Project	<b>IEEE 802.16 Broadband Wireless Access Working Group</b> < <a href="http://ieee802.org/16">http://ieee802.org/16</a> >	
Title	<b>Proposed Modifications to the IEEE 802.16m SDD, Section 5</b>	
Date Submitted	<b>2008-03-10</b>	
Source(s)	Yair Bourlas Lei Wang Ramon Khalona	Voice: E-mail: <a href="mailto:ybourlas@nextwave.com">ybourlas@nextwave.com</a>

# Proposed Modifications to the IEEE 802.16m SDD, Section 5

Figure 1 System Reference Model

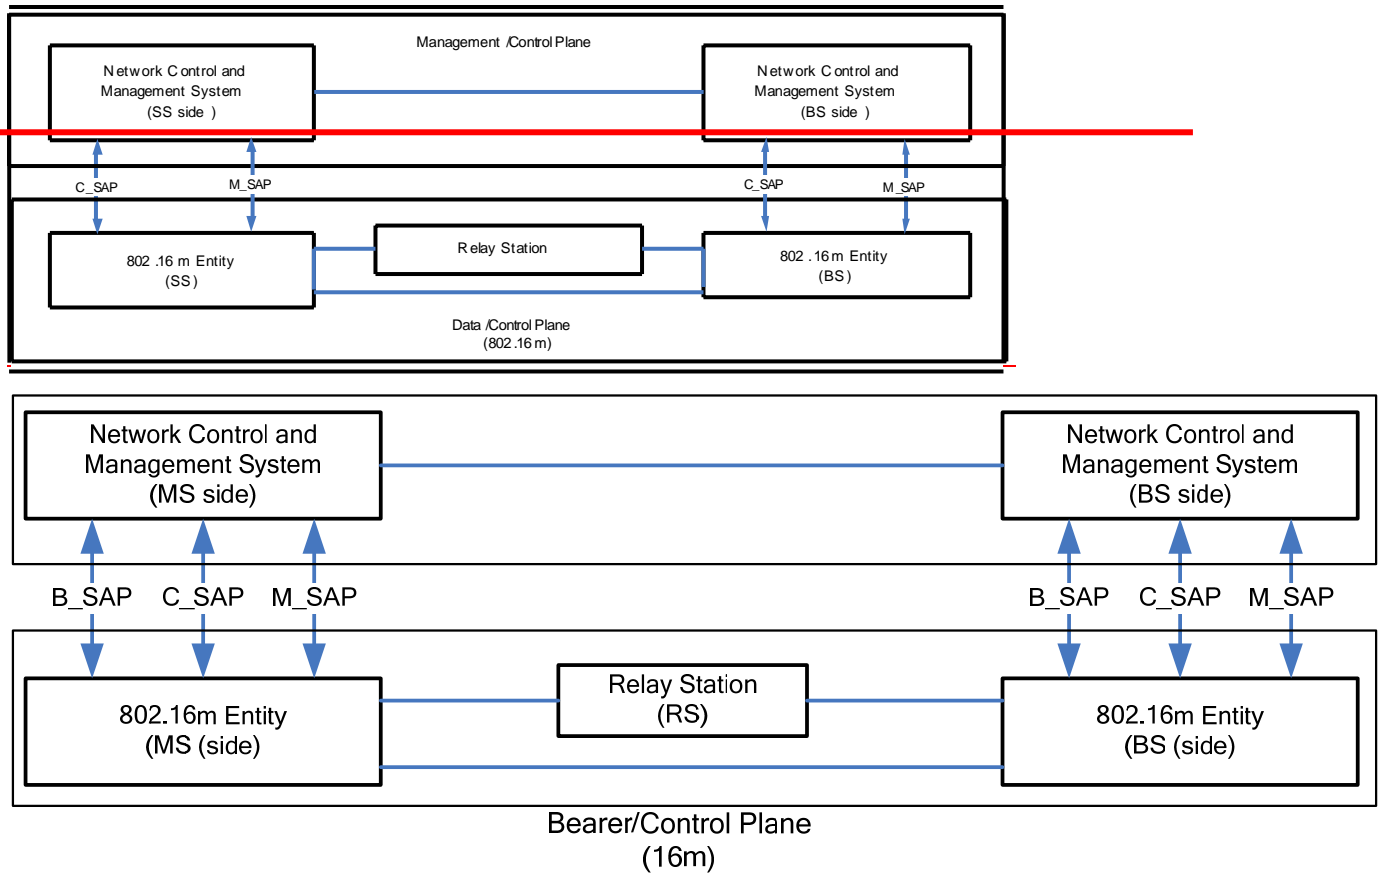
- Section 5
  - Modify Figure 3 to add Bearer SAP (B\_SAP). The implication is that the 802.16m entity has the following SAPs interfacing to the upper layer entities: management SAP (M\_SAP), Control SAP (C\_SAP) and Bearer SAP (B\_SAP). Note that we are using the term bearer instead of data SAP as it is less confusing.

A simplified reference model for 802.16 network is shown in Figure 1. An 802.16m entity is the logical entity in a SS, RS or BS that comprises the PHY and MAC layers of the [data bearer](#)/control plane. The Network Control and Management functions provide various control and management functions (including AAA, security, mobility, radio resource management, service flow management, paging and idle mode, MBS, location based services, MIH function, SS management, network management, regulatory services, multi-RAT interworking, etc.) and resides in both MS and BS. A set of SAPs provide interfaces between them and 802.16m entities.
